<p>Hillrom™ Hillrom Luleå Nedre Vägen 100, 975 92 Luleå, Sweden</p>	<p>Field Safety Notice</p>	<p>FA 2021-010-002-LUL-001</p>
--	-----------------------------------	---------------------------------------

Subject: Missing bushing on Liko M220 and M230 causing wear and potential for falls.

Commercial name of affected product: Liko M220, Liko M230

Figure 1: Mechanism and parts included in the sling bar for M220/M230. Bushing marked in red.

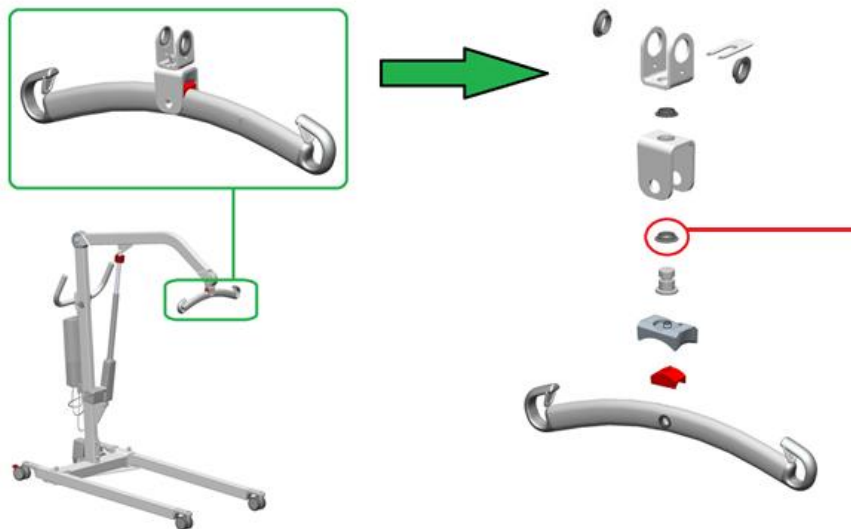
Hillrom has received customer complaints whereby a Slingbar had detached from the upper bracket of the sling bar attachment. Investigations indicated that a bushing was missing on the product. The missing bushing causes wear on the Slingbar attachment, which in turn can potentially cause the sling bar to detach from its attachment. If the slingbar detaches from the upper bracket, this has the potential for patient falls.

The sling bar on the Liko M220 and M230 mobile lift is locked into its position onto the lifting arm through two link plates, see figure 1. These two link plates are attached to each other through a bolt and a locking plate that allows for a rotation of the sling bar in one direction relative to the upper link plate.

Hillrom investigation determined that the root cause of the slingbar detachment is caused by wearing at the slingbar attachment due to the missing of a plastic bushing (see red markings in Figure 1) as part of the assembly during manufacturing of the device. It was determined that assembly of this device has the potential to not contain this plastic bushing on devices manufactured between 2016-DEC-27 and 2021-SEP-01.

A missing plastic bushing on the device can cause wearing on the slingbar attachment. Over time, this wearing can cause the slingbar to detach from the lift, which may result in a patient fall. Hillrom can confirm there have been no death or serious injuries reported from this failure.

Upon receipt of the response form, identifying potentially impacted devices, Hillrom or an official Hillrom distributor/representative will be in contact to schedule inspection of your device to confirm presence of the bushing. Where it is confirmed that the device is missing the bushing, a replacement slingbar with the bushing will be installed.

Figure 2: Placement of the label and its designs. Left: New design. Right: Old design.

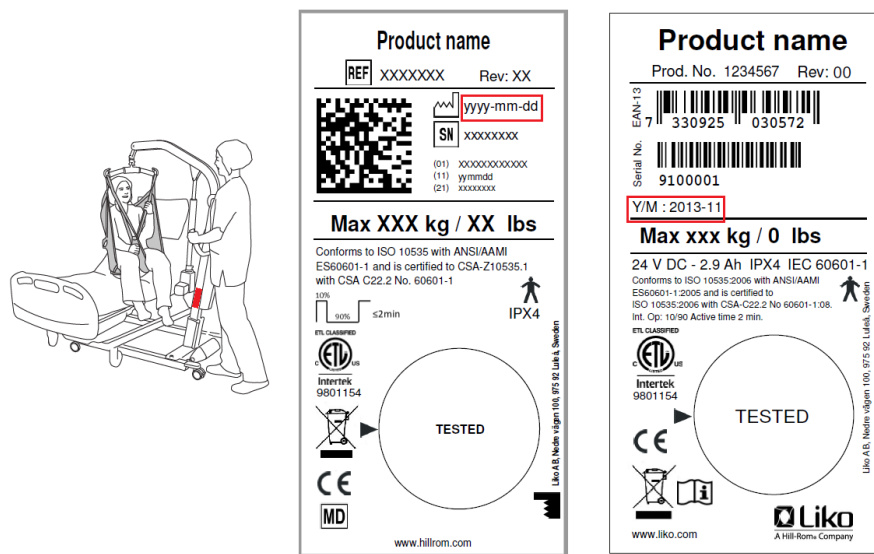
1. Review the product label on your Liko M220/M230 to determine if it is impacted by this field action by identifying the manufacturing date of the device (i.e. Manufacturing date between 2016-DEC-27 and 2021-SEP-01). See figure 2.
